Re: Wireless Communication Facility, 16 Bell Mountain Road Extension, Cornwall

This letter is in response to your request to have the Northwest Conservation District (NCD) perform an environmental review of the proposed access road to a cell tower compound. I reviewed the engineered design sheets (provided by Centek Engineering) and I visited the site on the afternoon of July 14, 2010. Please consider the following comments and recommendation when reviewing this proposal.

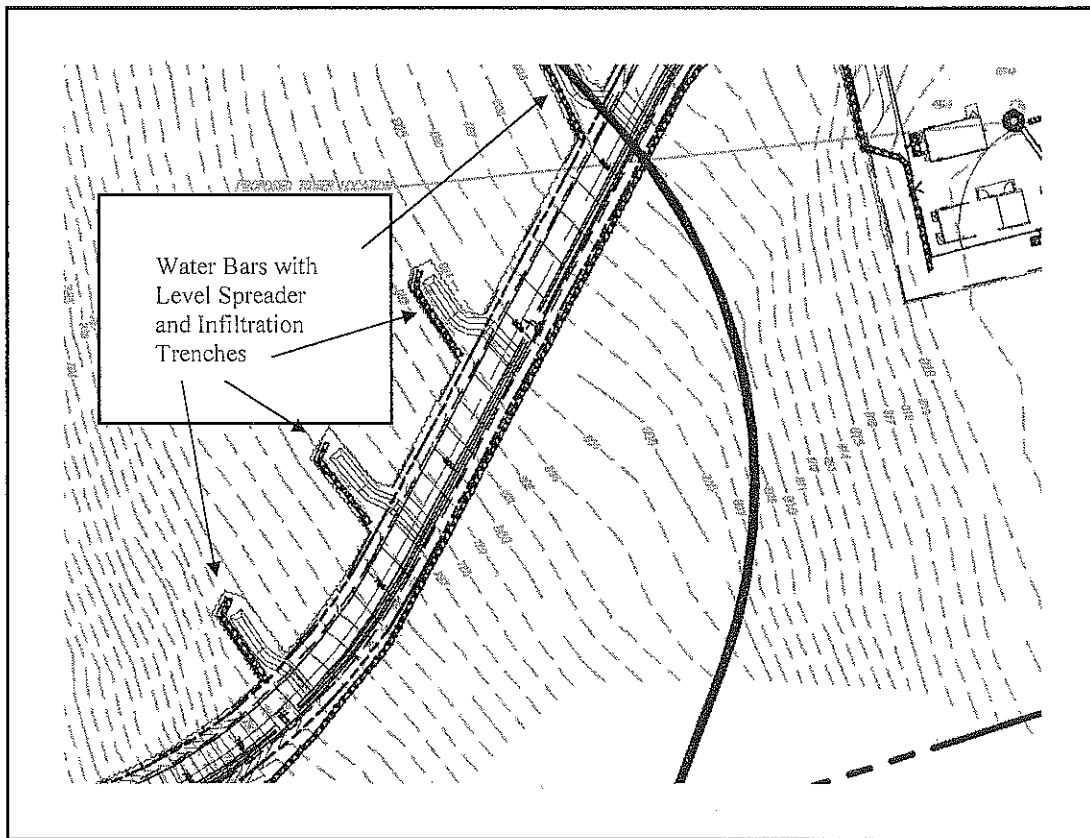
- 1) On Page 5-7-6 of CT DEP, 2002 there is a table that describes water bar intervals on either a construction road or a gravel road. Roads with slopes greater than 15% should have a water bar every 50 feet or less. As currently proposed there are no water bars proposed on the design sheets. This will be an important measure to include because a crushed stone road, with or without a geo-grid layer, will compact and become impervious. Therefore, the proposed road will be generating much more stormwater runoff as compared to current conditions. In addition, each water bar should have an energy dissipater, and a measure to infiltrate at least some stormwater runoff. As currently designed stormwater runoff will be shunted off the road and onto the surrounding steep slopes that contain highly erodible soils. An example of how stormwater runoff is managed more effectively on a steep grade is pictured below.
